**CITY OF LA VISTA**  
**MAYOR AND CITY COUNCIL REPORT**  
**APRIL 4, 2017 AGENDA**

<b>Subject:</b>	<b>Type:</b>	<b>Submitted By:</b>
APPLICATION FOR PRELIMINARY PLAT – LOT 2, LAKEVIEW SOUTH II REPLAT 6 & S 1551.37 FT OF TAX LOT 4, 23-14-11 (NW OF 145 <sup>TH</sup> & MEADOWS BLVD.)	◆ RESOLUTION ORDINANCE RECEIVE/FILE	ANN BIRCH COMMUNITY DEVELOPMENT DIRECTOR

## Heimes Lots 1-5

RE: Preliminary Plat Application – Initial Review  
Heimes

# HEIMES

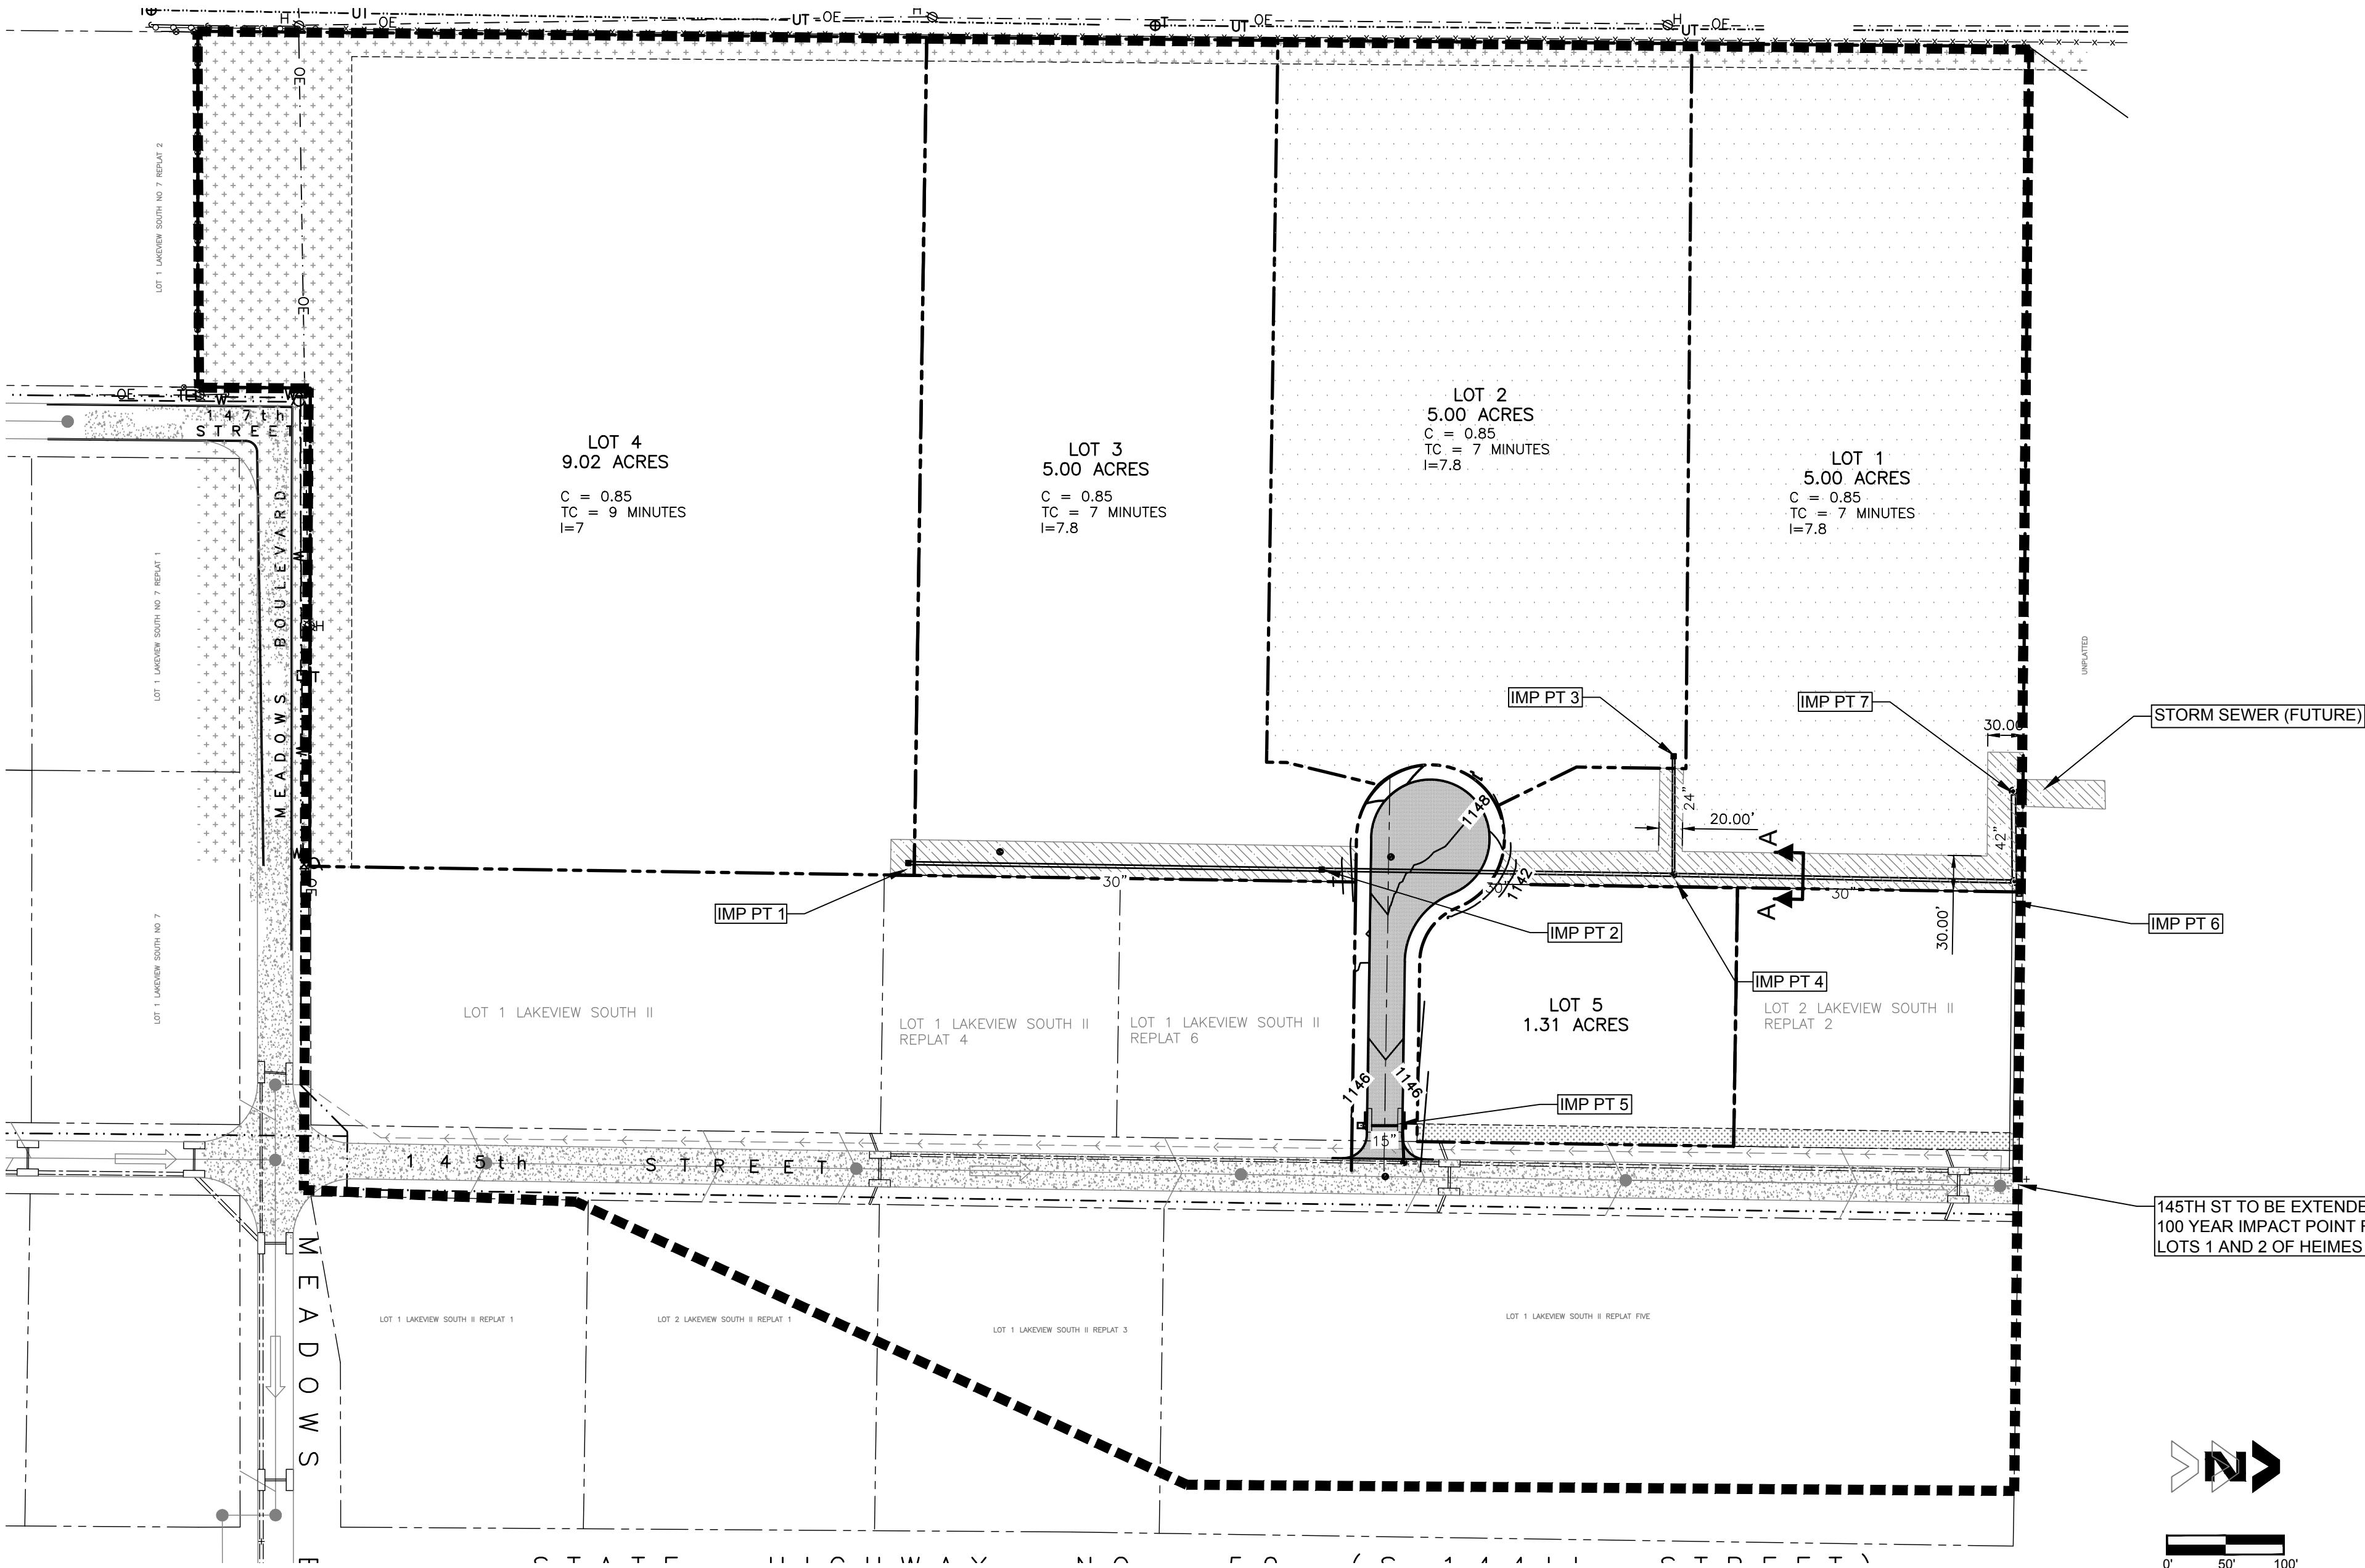
1. The graphic scale shown on the plat appears to be incorrect. It is labelled as 60 scale but it appears the drawing is 100 scale.
2. The preliminary plat should be sent to the Papio-Missouri River Natural Resources District for review and comment since it abuts the Wehrspann Lake Dam Site which is maintained by the PMRNRD.

3. Under the title on the plat there appears to be an extraneous note "Lot 1, Lakeview South II Replat Five" that needs to be removed just to avoid confusion.

4. In regards to the proposed cul-de-sac, a street name needs to be assigned by City staff, in conjunction with Sarpy County GIS and Sarpy County 911. A determination will be forwarded upon the finalization of a name. For compliance with Article 3.03.10 some additional notes concerning the proposed public street are needed to identify the thickness of the proposed pavement (9" required) and corner radii at 145<sup>th</sup> Street.

6. A proposed storm sewer and water easement is shown on the preliminary plat to the north line of proposed Lot 1. The location of the drainage easement

that continues to the north in the Woodhouse Place preliminary plat needs to be shown to illustrate coordination. There also needs to be explanation for calling this a water easement since the Woodhouse Place preliminary plat does not identify a water easement, just a storm sewer easement. The easements will need to be granted to the entity that will be responsible for operation and maintenance of the improvements. This can be resolved as part of the final plat and subdivision agreement process.

10. The drainage study needs to include additional information. The boundary of the total drainage area to Impact Pt. 7 needs to be illustrated. Major storm drainage calculations are needed to identify that 100-year peak flows can be contained within the right of way of the proposed cul-de-sac street and within the width of the proposed storm sewer easement on Lot 1. The plan also needs to include notations as to how compliance with the requirements for no increase in 2-year peak flows above existing conditions, 10-year peak flows not exceeding 125% of existing condition peak flows and water quality treatment for the first half-inch of runoff will be provided.

2. In regards to the proposed cul-de-sac, please label the street name as Portal Circle.
3. The water to serve this development needs to come from the Metropolitan Utilities District and a notation to that effect has been added to the plat.
4. In accordance with Article 3.03.15 of the Subdivision Regulations itemized cost estimates for public improvements need to be submitted including proposed sources of funding. The proposed cul-de-sac lies largely within property situated in SID 48. Is it proposed that SID 48 will build and maintain the road? The proposed sanitary sewer connects to an existing sanitary sewer in 145<sup>th</sup> Street that drains to an existing lift station. The preliminary needs to indicate if the intent is to remove the lift station which is implied by Note 8 on the revised preliminary plat. Tract sewer connection fees will be collected on this

- 1) The Scale has been corrected.
- 2) The plans have been sent to Amanda Grint with the Papio NRD for review and comment.
- 3) The note has been removed.

- 4) Paving thickness has been added on the legend, and the radii have been added as well.
- 5) A note has been added that MUD water will be serving the subdivision.

- 6) The easement information has been updated.
- 7) A cost sheet has been prepared and is attached.
- 8) A note stating that each lot will be required to get its own grading permit.

- 9) A trip generation report was generated by FHU and is attached.
- 10) The drainage study was updated to show impact points for both the 10 and 100 year storms. The calculations showing that 145<sup>th</sup> Street can handle the flows have also been attached. A note was included to list the requirements for stormwater requirements.

- 1) Once comments have been received from the Papio-Missouri River Natural Resources District adjustments will be made as required.
- 2) The cul-de-sac has been labelled Portal Circle.
